**DEVIATION REVIEW  
AND DECISION FORM**

**Monument Academy - Deviation No. 1**  
**Updated 8/14/2019**

Subdivision or Project Name: Monument Academy

**Monument Academy - Deviation No. 2**

**ROAD A PLAN & PROFILE**

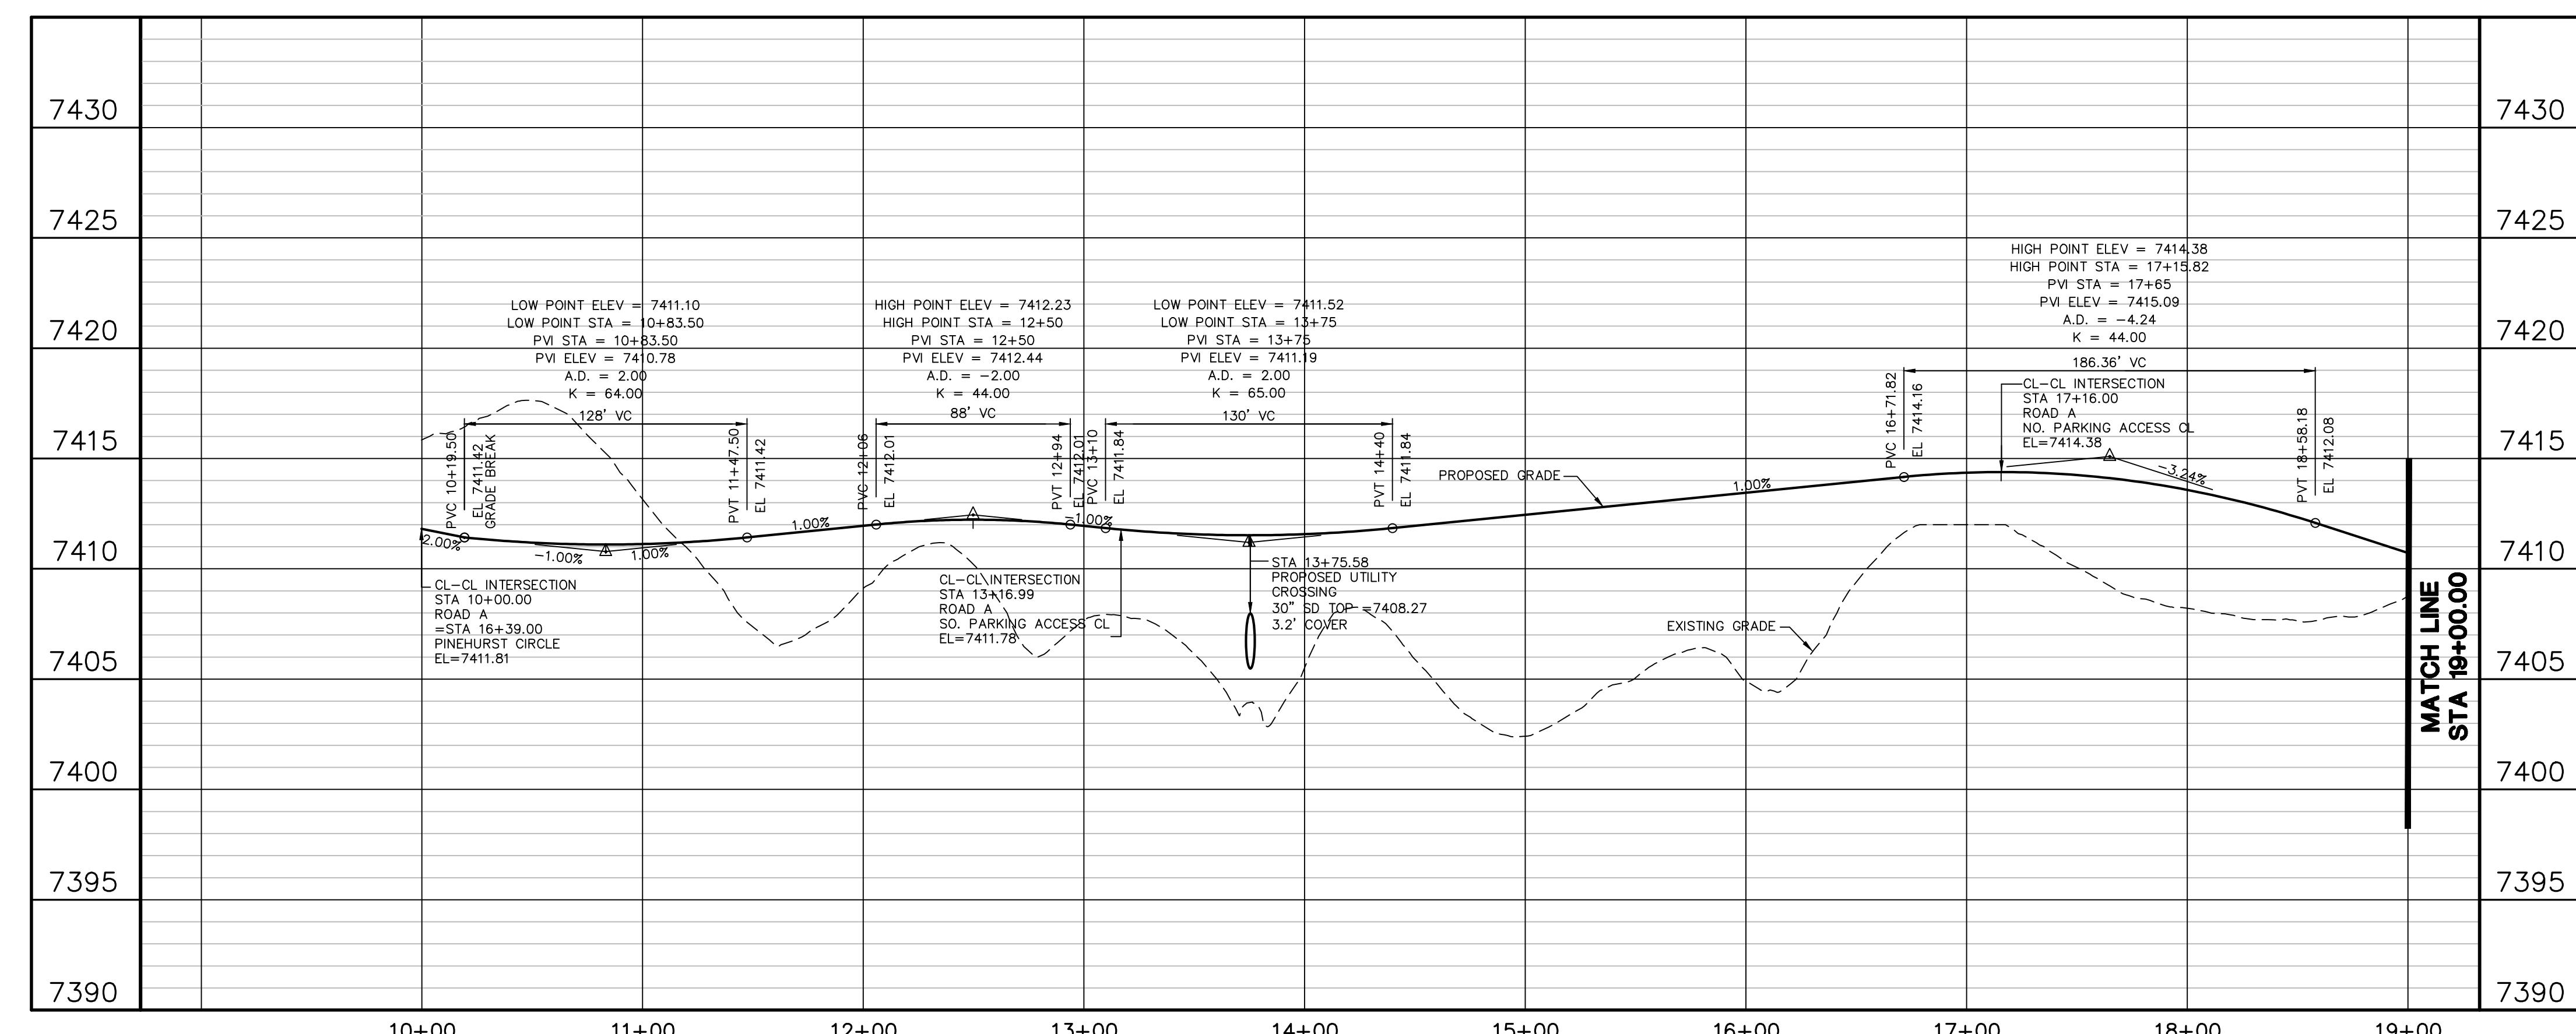
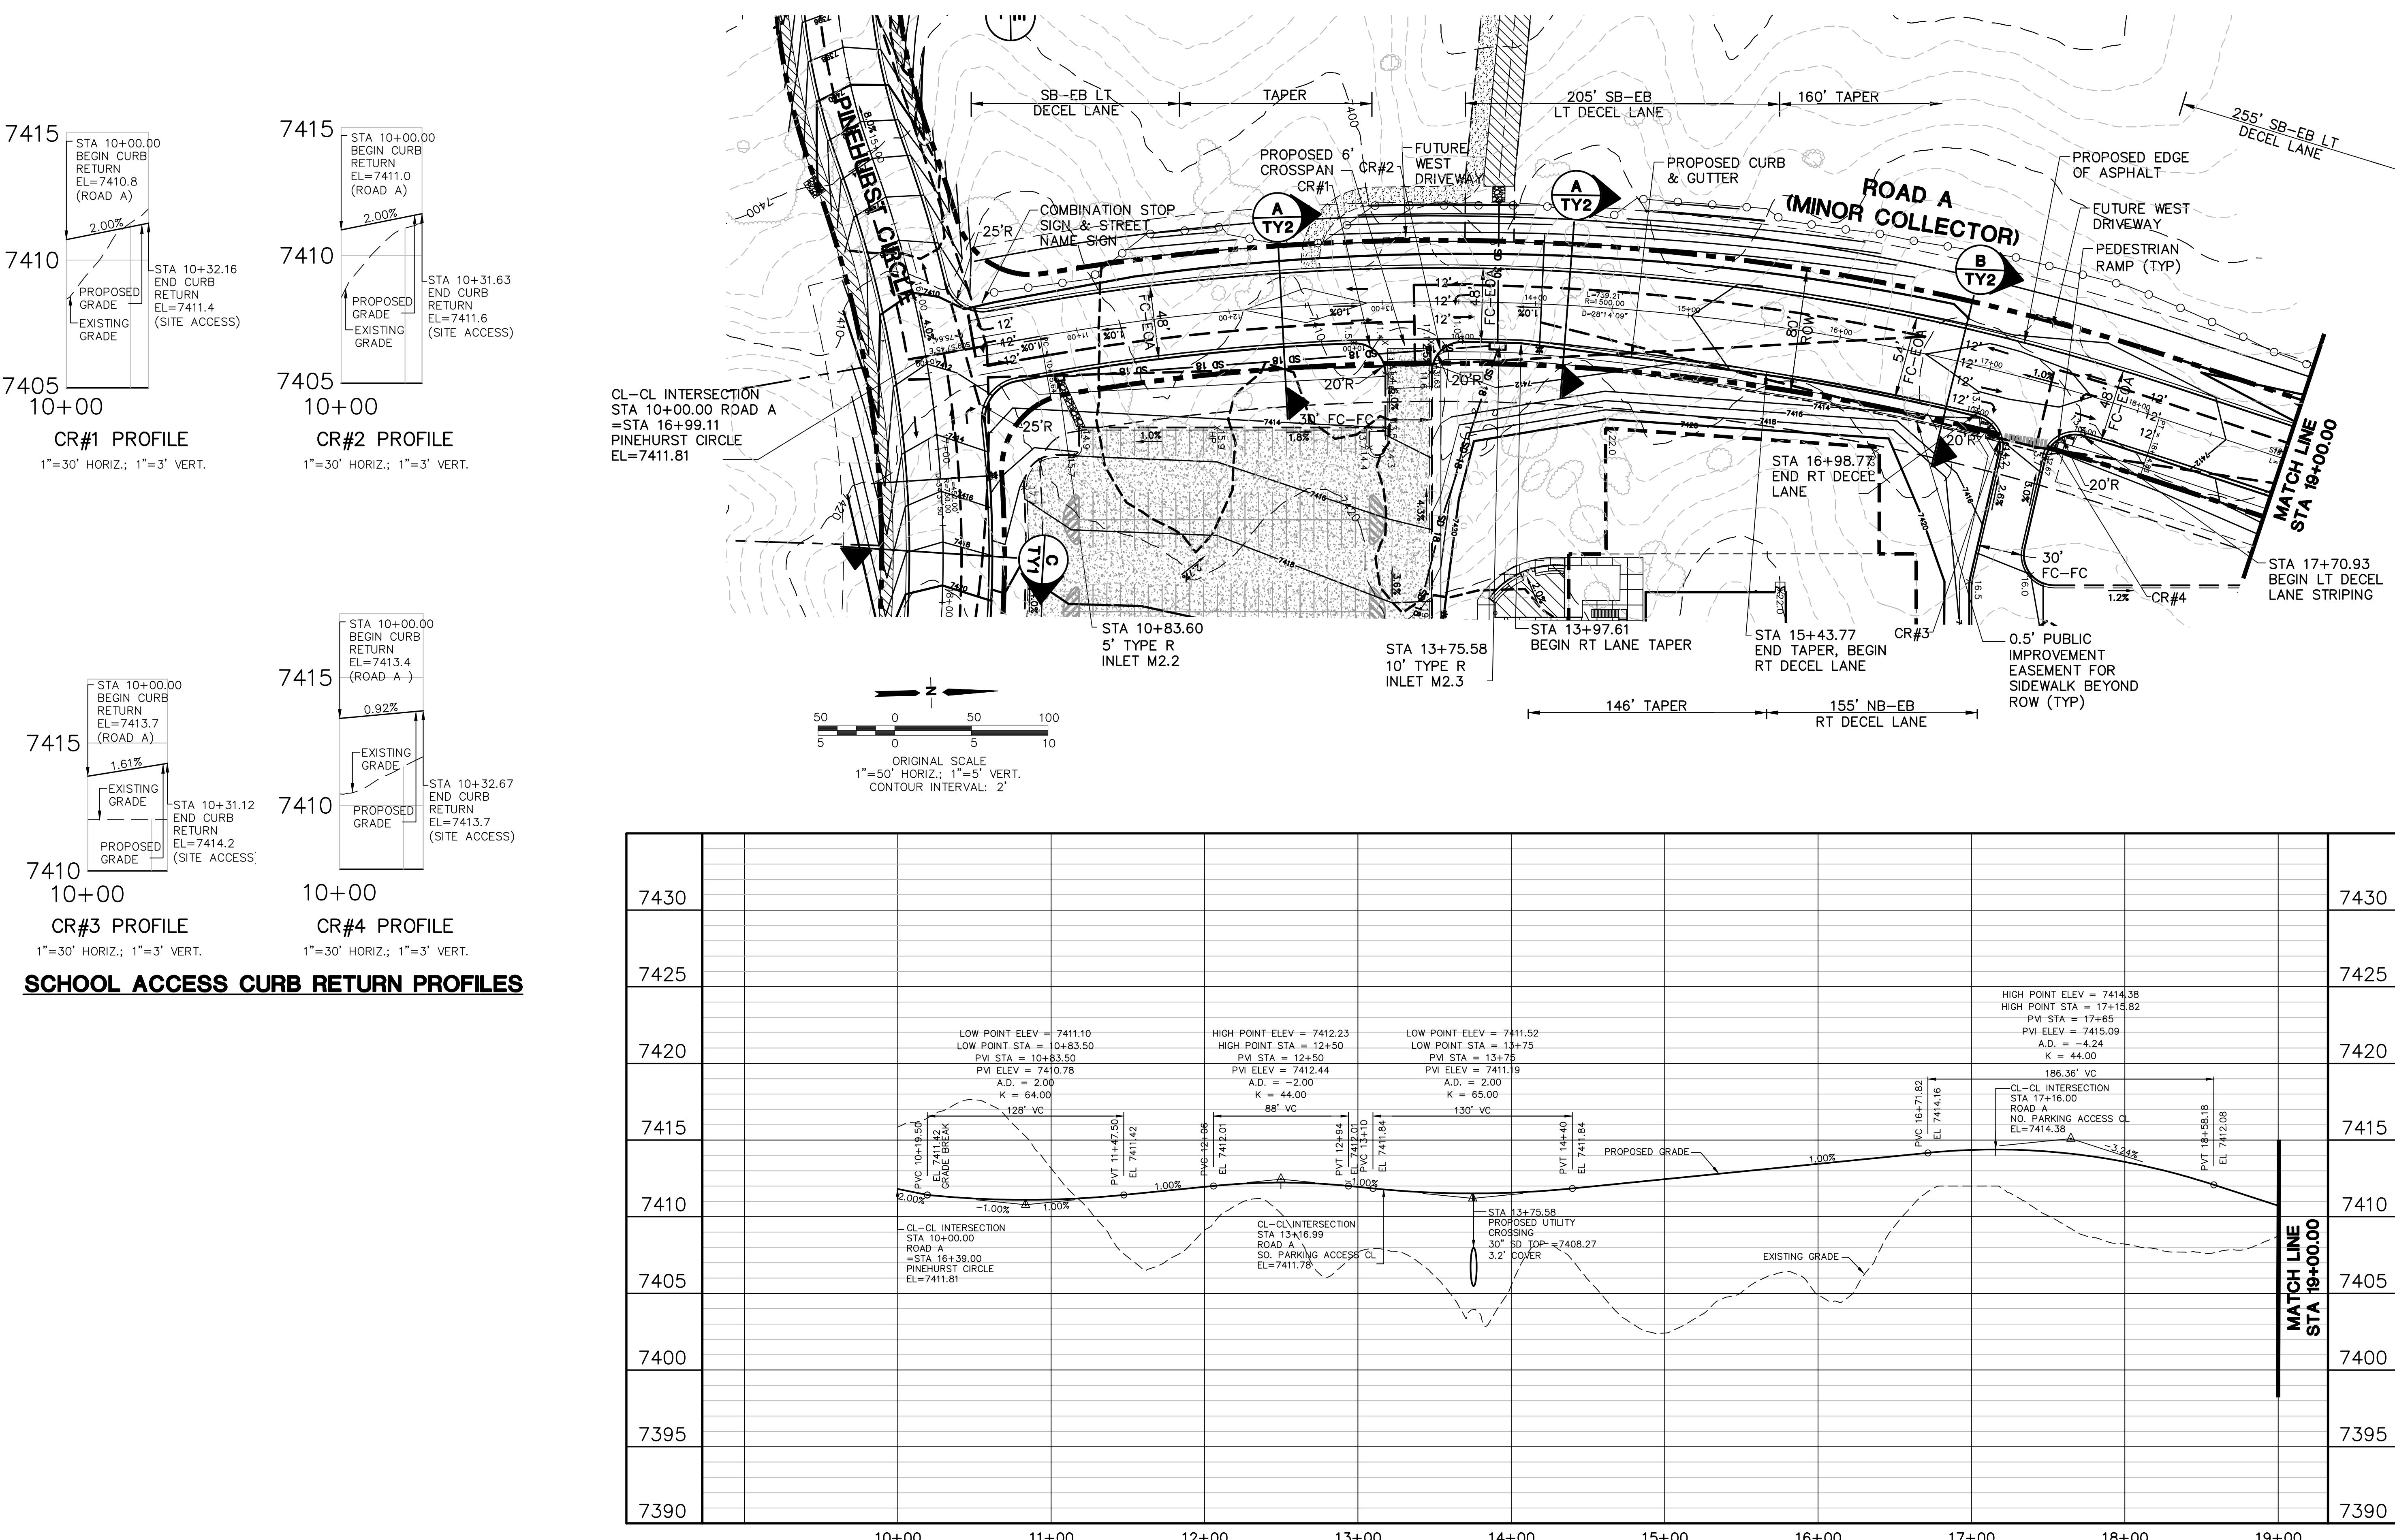
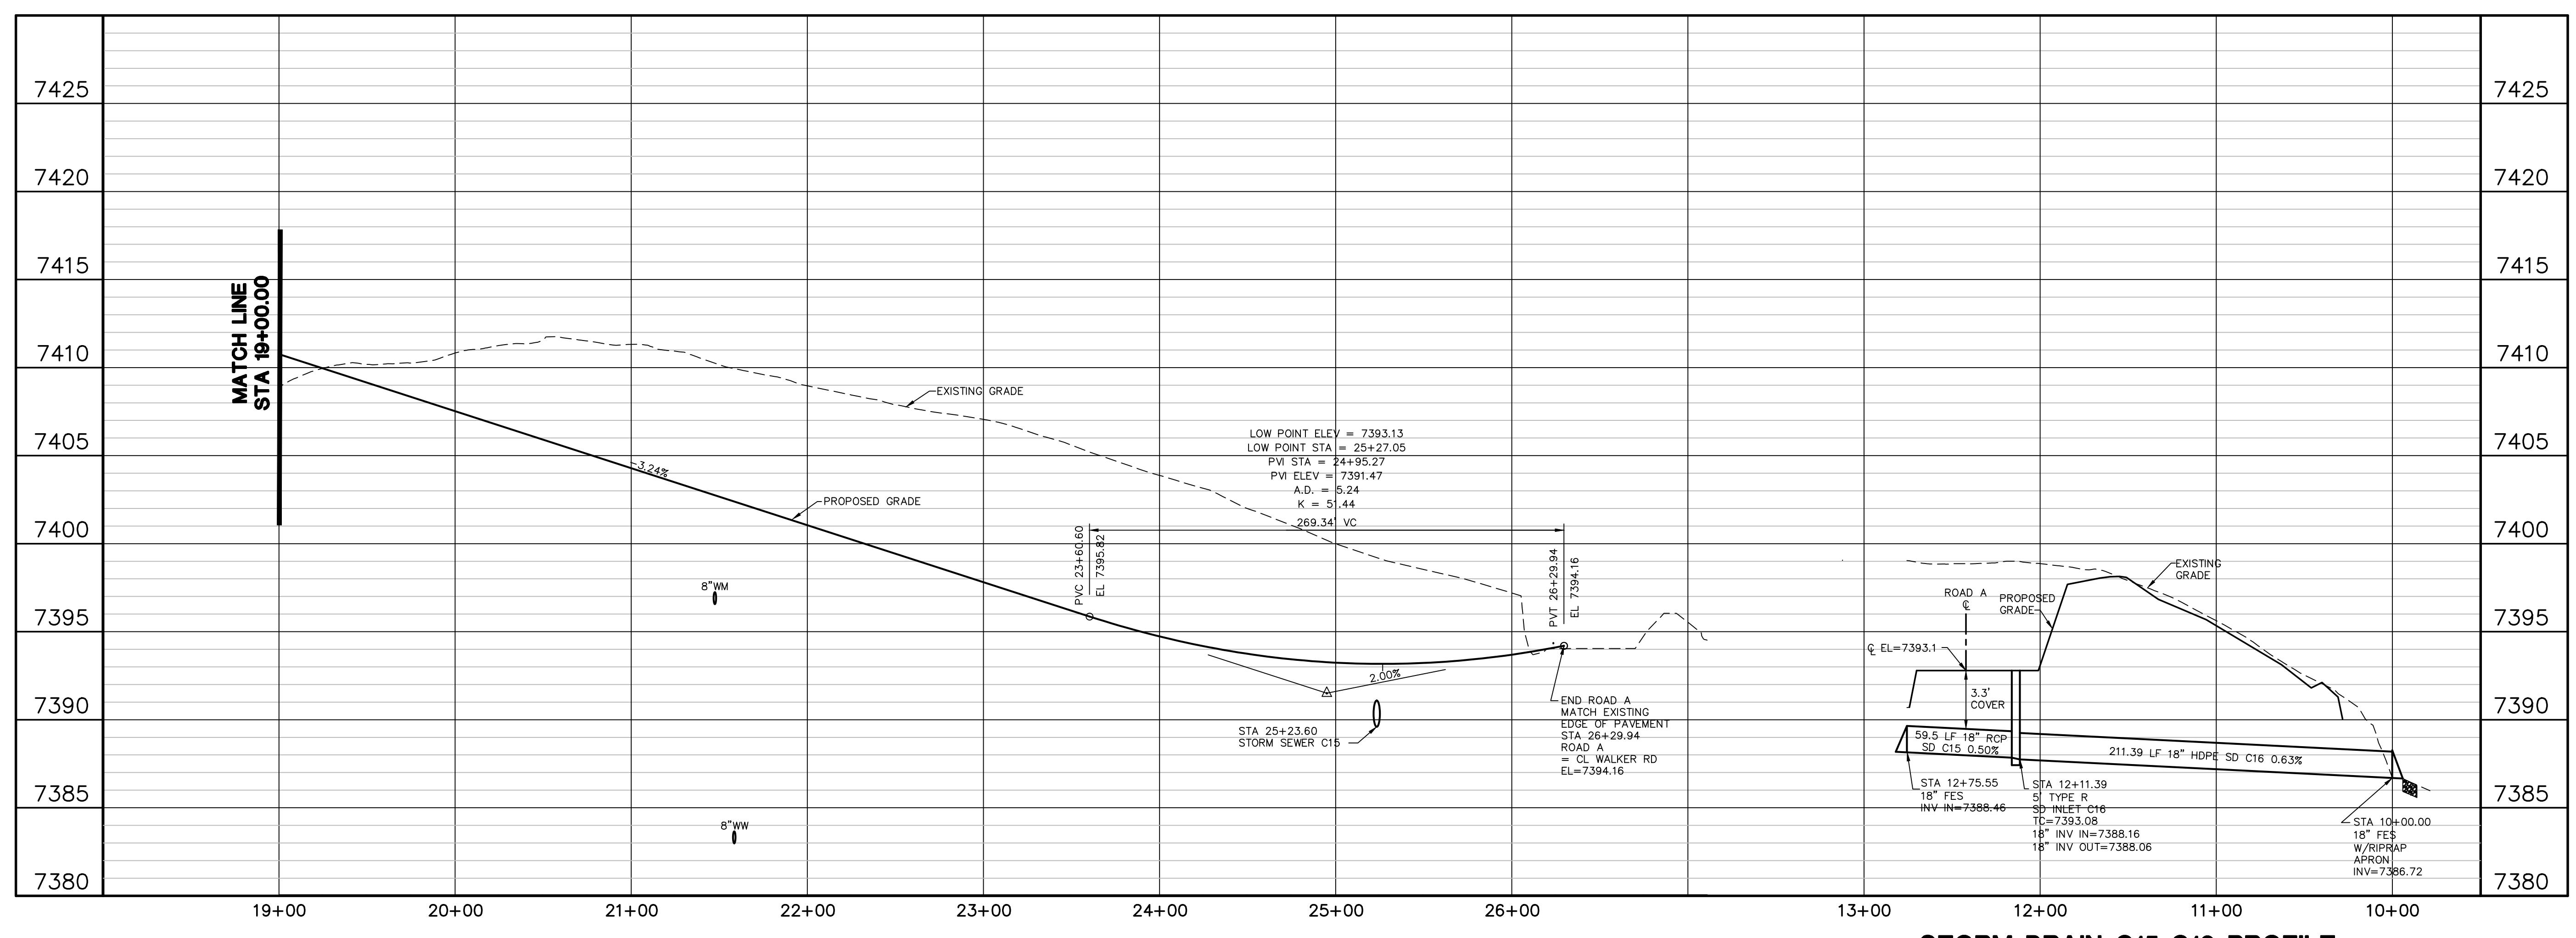
Specify when (all with first lot on west side? with subdivision?). Is the developer going to maintain the road until it is completed?

### Address traffic volumes - with the amount of traffic using the road (2,500 to 3,400 ADT), curb should be provided
